**ESENCIA K-8 PORTABLES PHASE 2 PROJECT
Bid No. 2324-09**

**ADDENDUM NO. 2
May 6, 2024**

Subject: **ESENCIA K-8 SCHOOL
MODULAR CLASSROOMS**
Capistrano Unified School District

ADDENDUM No. 2

ELECTRICAL ENLARGED SITE PLAN

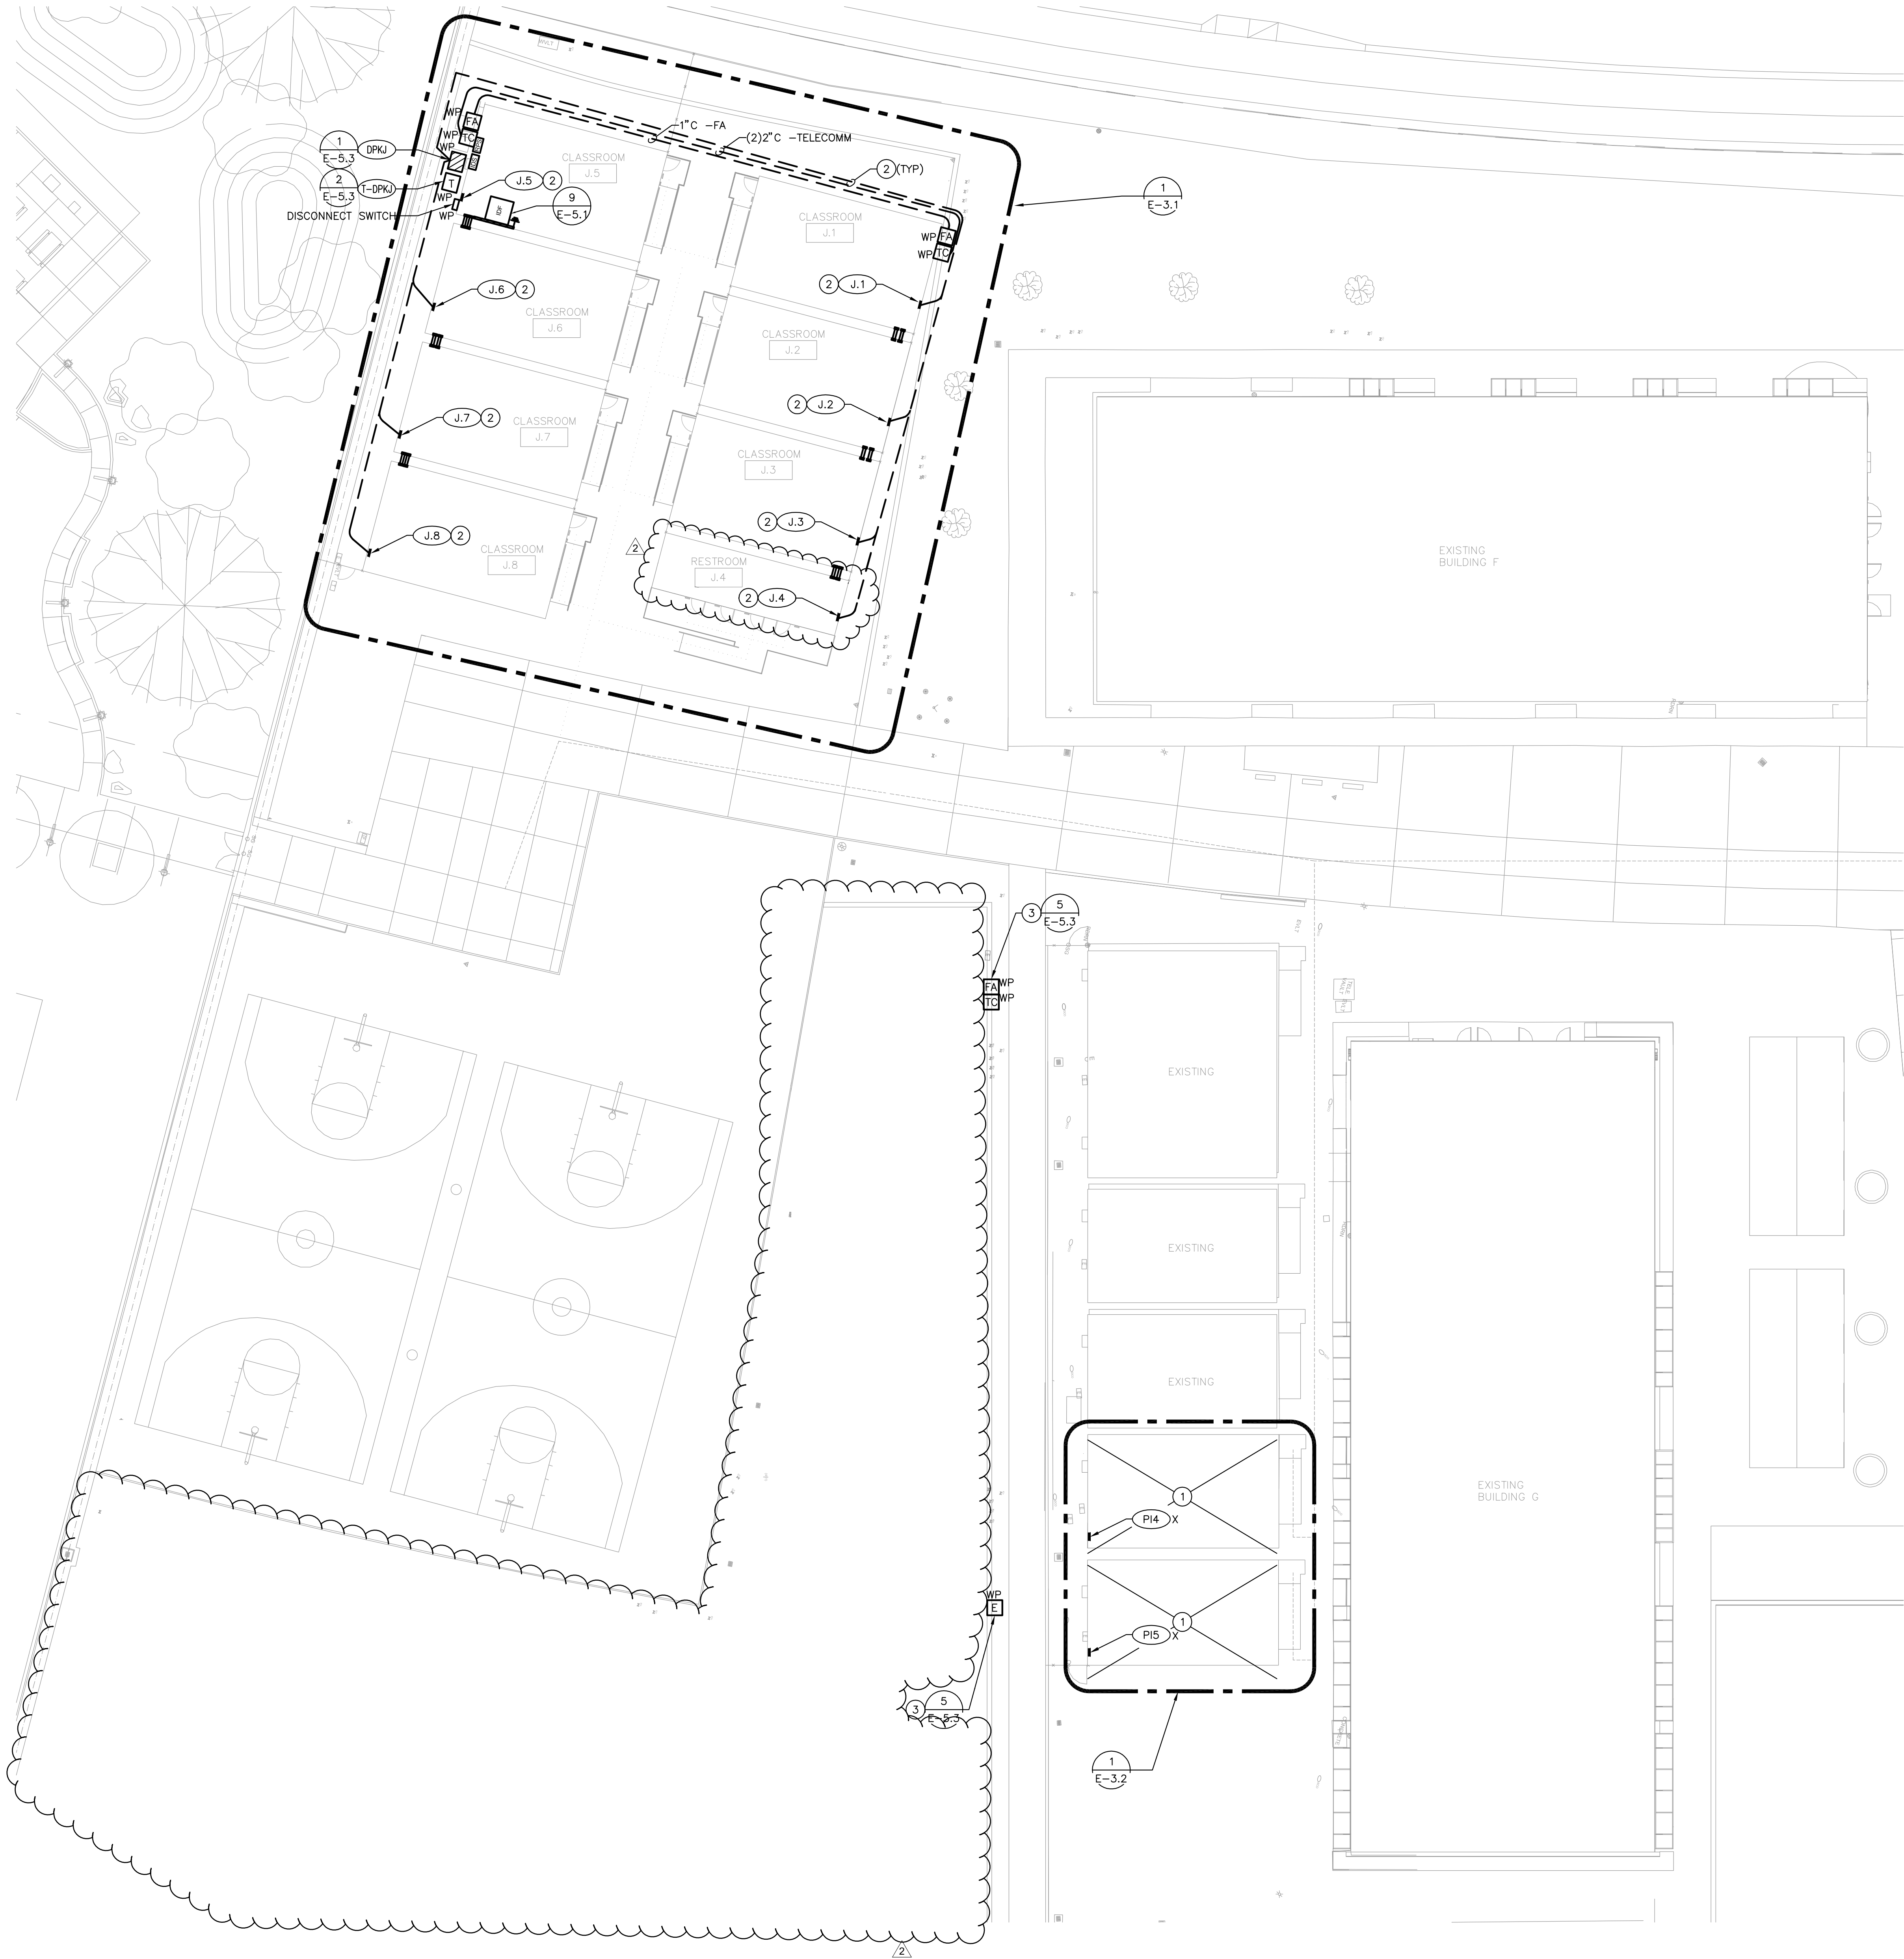
- A. At Electrical Enlarged Site Plan, revise building J.4 electrical panel location and associated connection to site power distribution system.
- B. At Electrical Enlarged Site Plan, delete new asphalt paving south of existing Bldg I-1 through I-5, and east of existing asphalt paved basketball courts area. Delete "Future" portable buildings (shown dashed). Delete new basketball courts east of existing asphalt paved basketball courts area. All existing construction in these areas is to remain.

NETWORK DATA RISER DIAGRAM (YMCA) 3

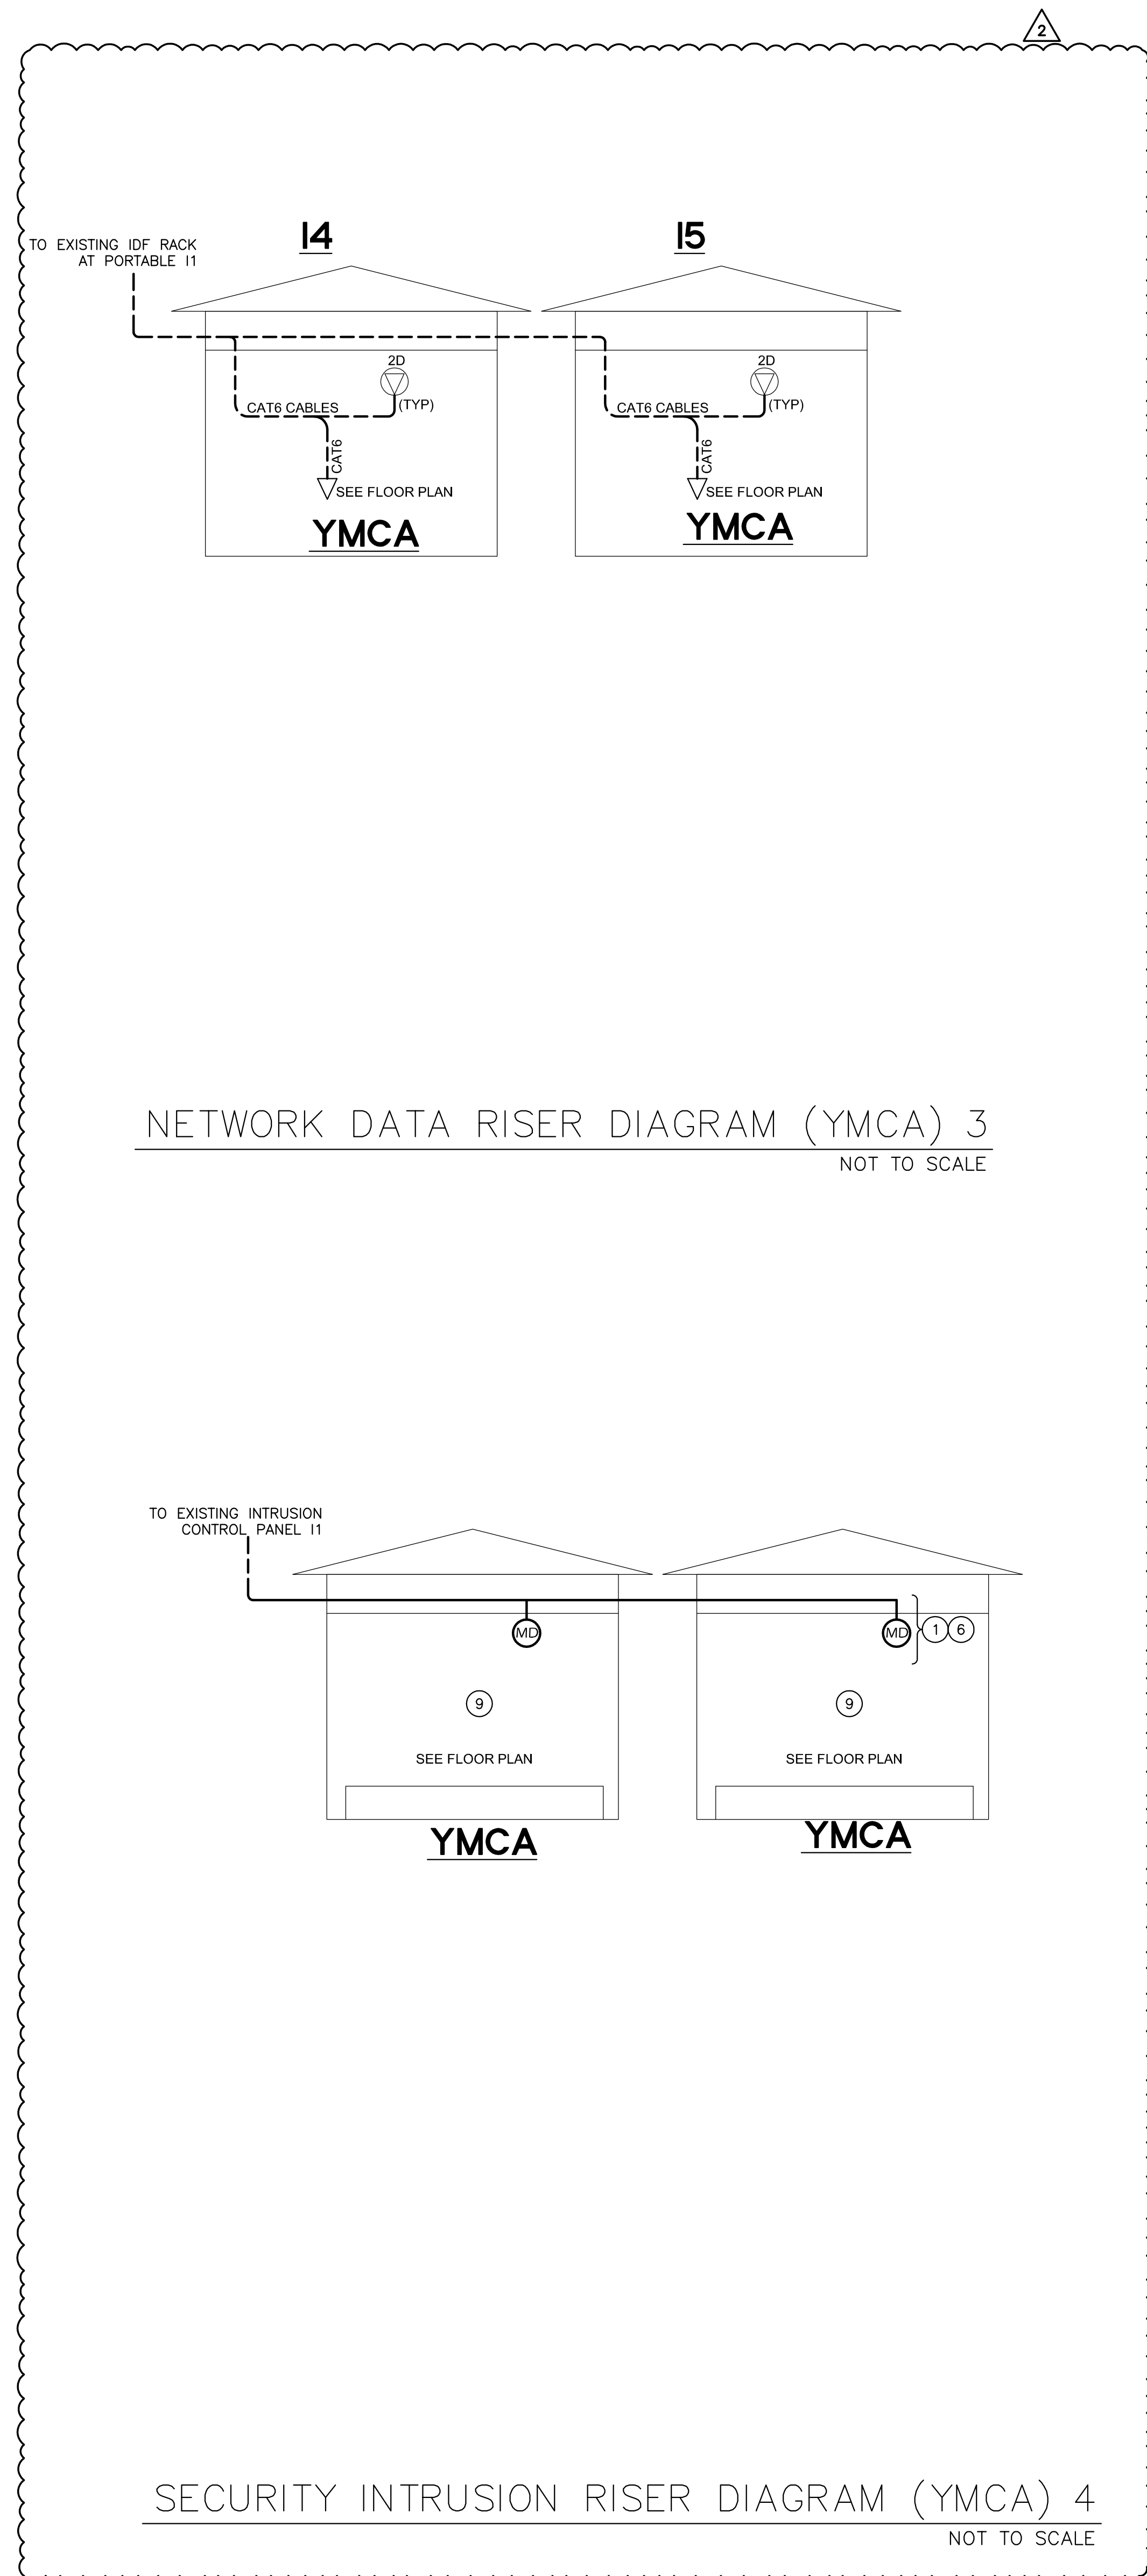
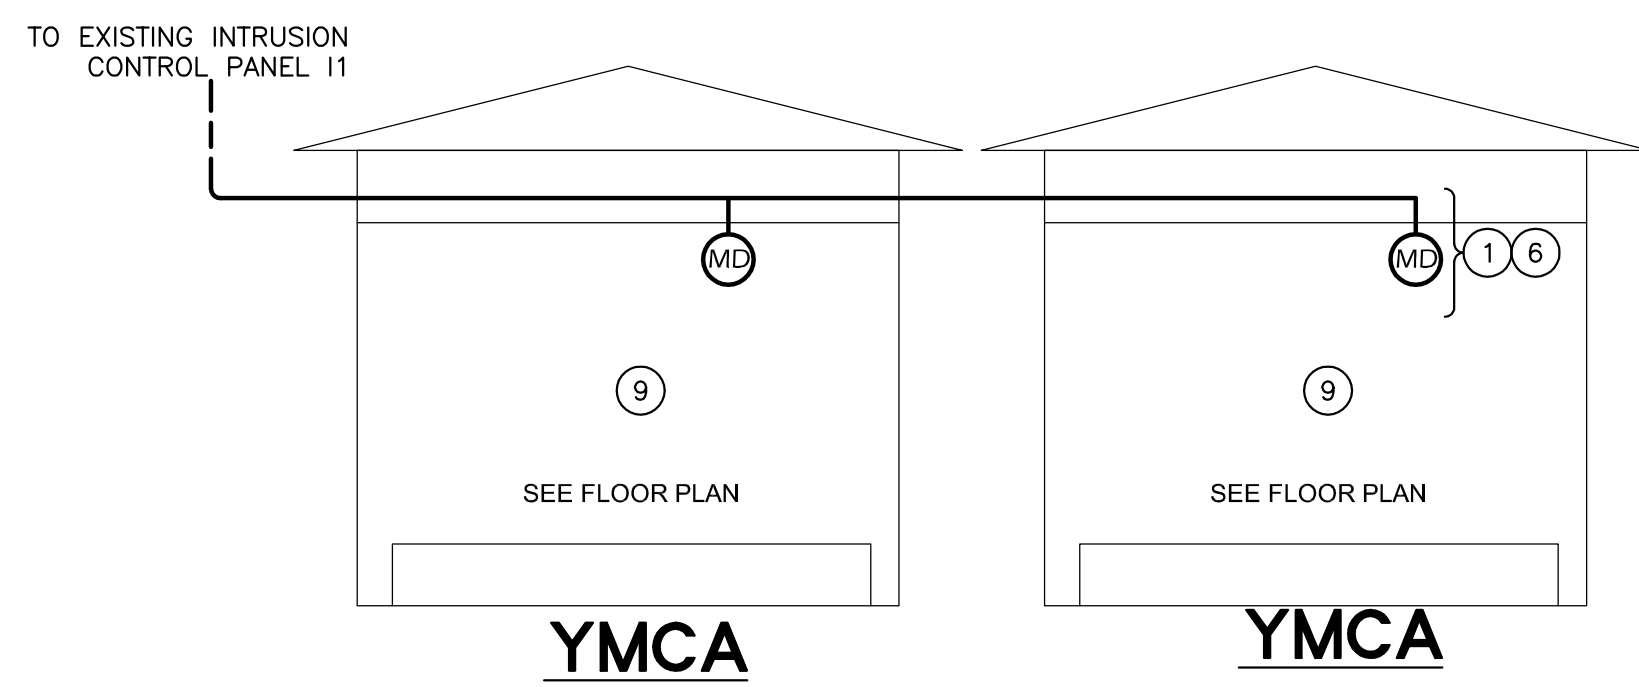
- A. Add detail 3 Network Data Riser Diagram (YMCA) in it's entirety.
- B. Add detail 4 Security Intrusion Riser Diagram (YMCA) in it's entirety.
